RE: Proposed Redwood PUD Development in the Southwest Quadrant of Avon and Dequindre
City File #18-022, Parcel No. 15-13-476-005
Final PUD Plan – Planning review #2 – DPS/Engineering

RE: Redwood at Rochester Hills (City File 18-022) Section 13

Please find enclosed two (2) sets of plans for the proposed Redwood at Rochester Hills project. The enclosed plans have been updated to address comments in your letter to me dated June 25 and in your memo to Kristen Kapelanski dated June 19.

C601

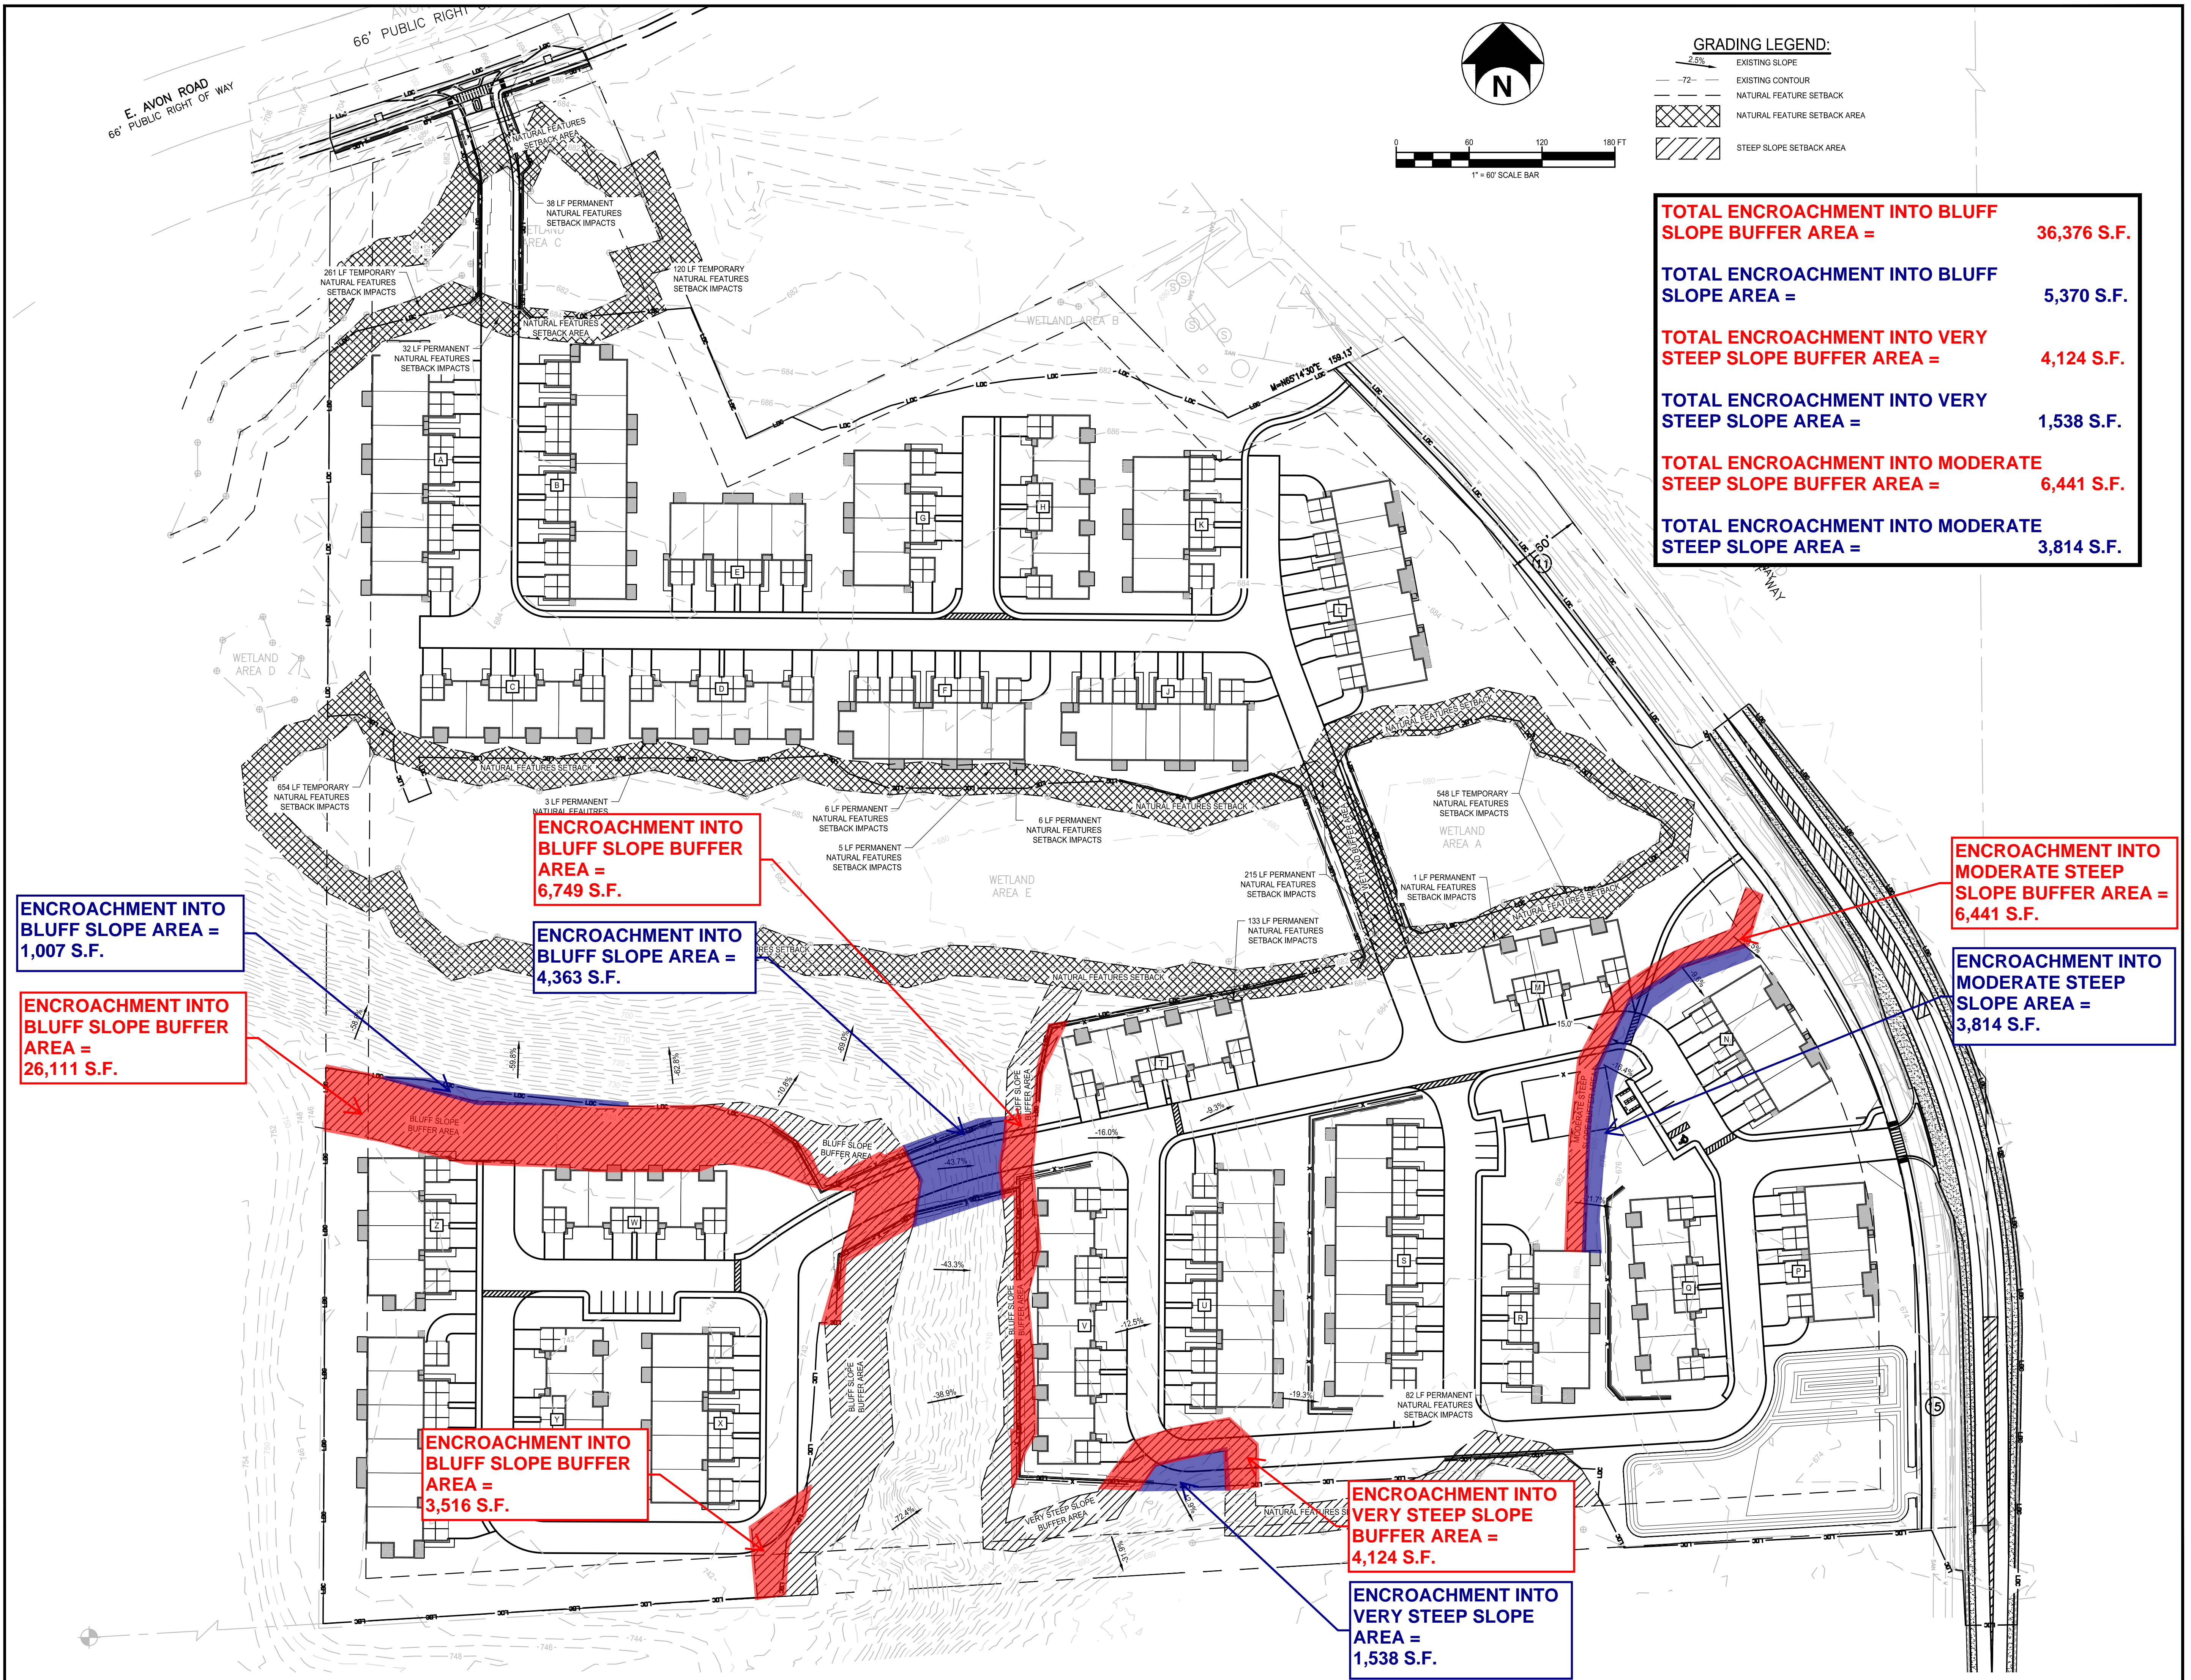
Comment 1: A steep slope permit will be required from the planning commission for the proposed development. The developer and engineer went through multiple layouts before determining this layout, which minimized the impact to the existing steep slopes on the property along with the setbacks associated with those steep slopes.

Response: The applicant acknowledges this requirement. Please note that an exhibit drawing was prepared and submitted to the Planning Department in a separate email. A copy of this document is included with this cover letter.
